Bids and Awards Committee

Project Title: Security Manpower Services for SEC Main Office and Extension Offices

Bid Bulletin No.1

PROPOSED LOCATION OF CCTV CAMERAS

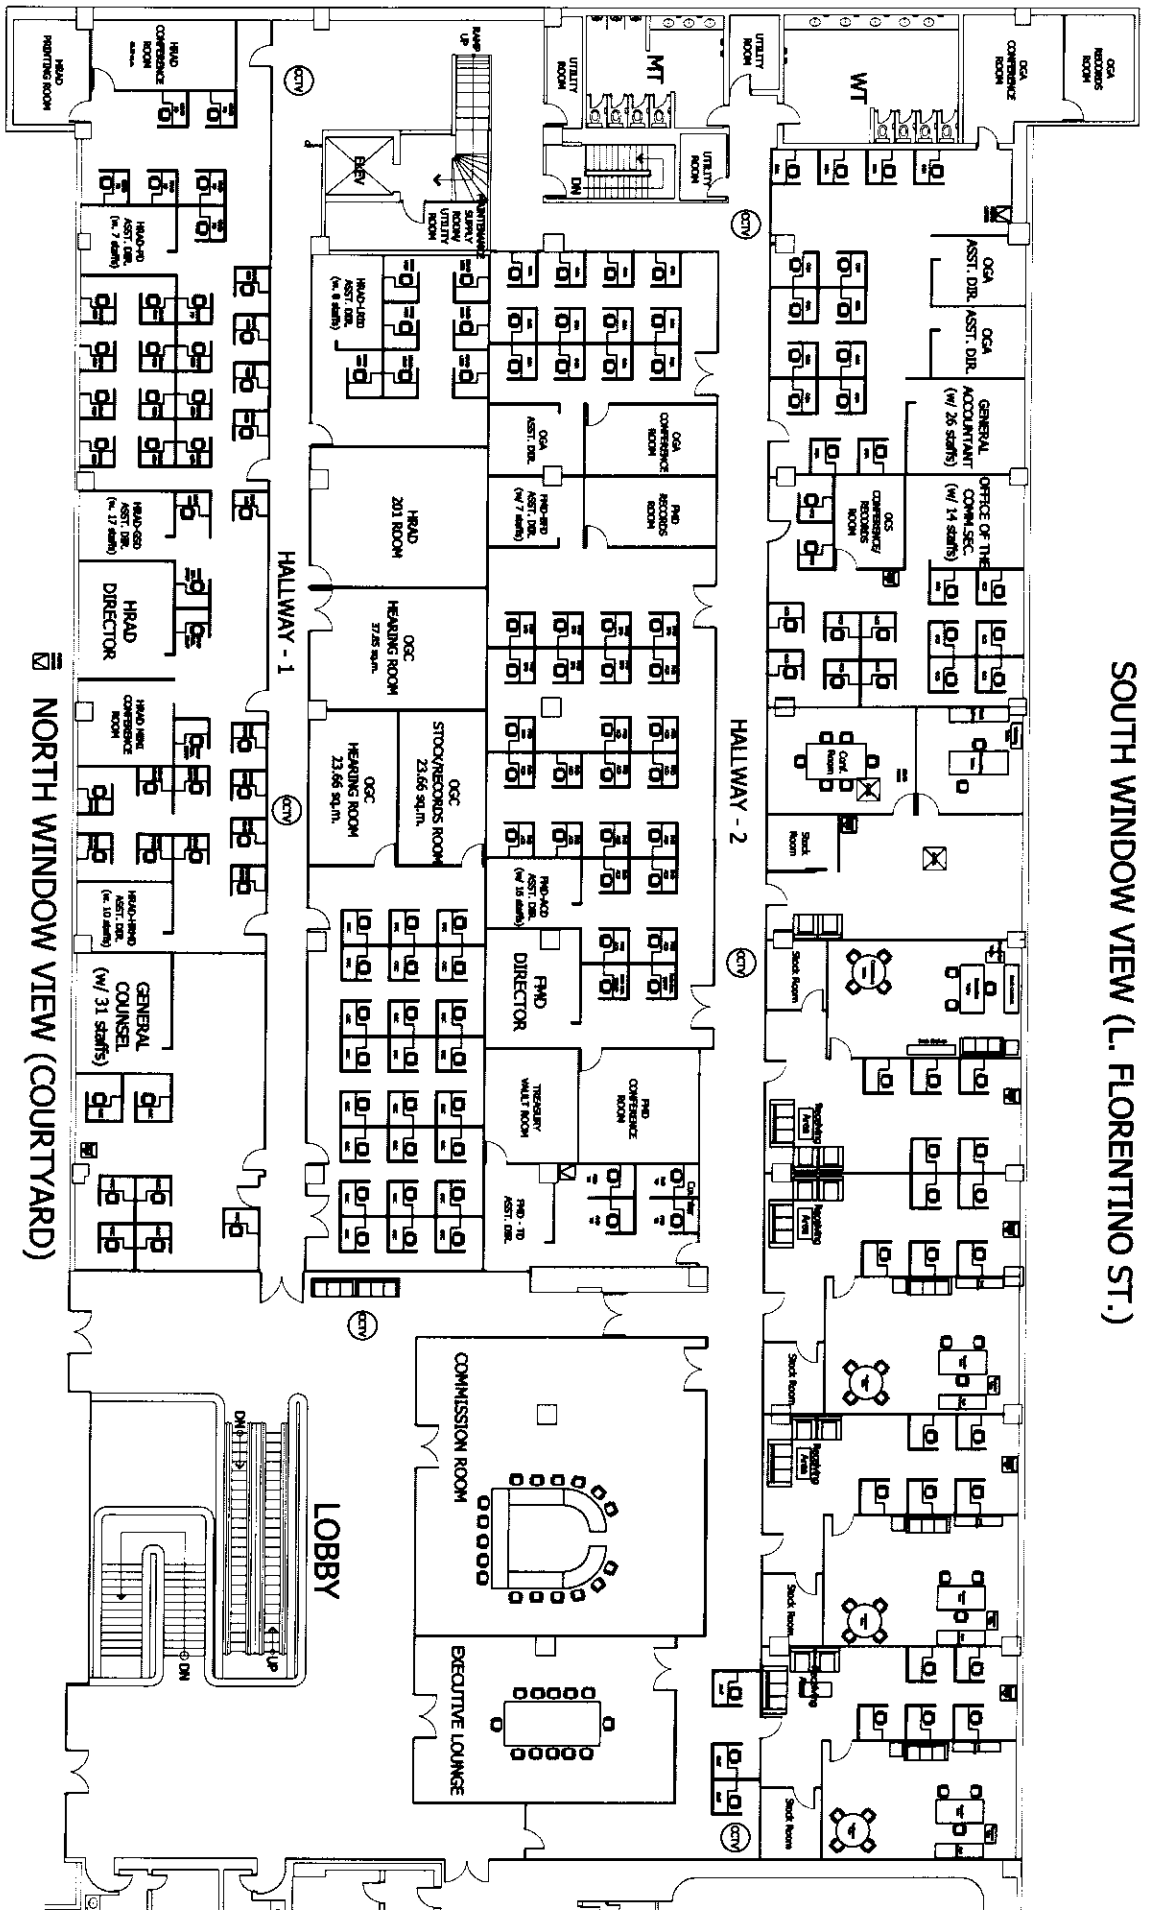
PARTICULARS	AMENDMENT/CLARIFICATION
Page 61, Additional Requirement (B.1 SEC HEAD Office) Item No.3 33 units of CCTV Cameras, High Resolution	See attached Proposed Installation of CCTV-Cameras with Office Layout.
Page 65, Section VII. Technical Specification under Item No. II Years of Experience	Prospective bidders must submit a certification issued by the Supervisory Office for Security and Investigation Agency of PNP or issued by the President of the Security Agency under oath supported by contracts.
Page 65, Section VII. Technical Specification under Item No. III Security Plan	Prospective bidders to submit their respective detailed Security Plan.
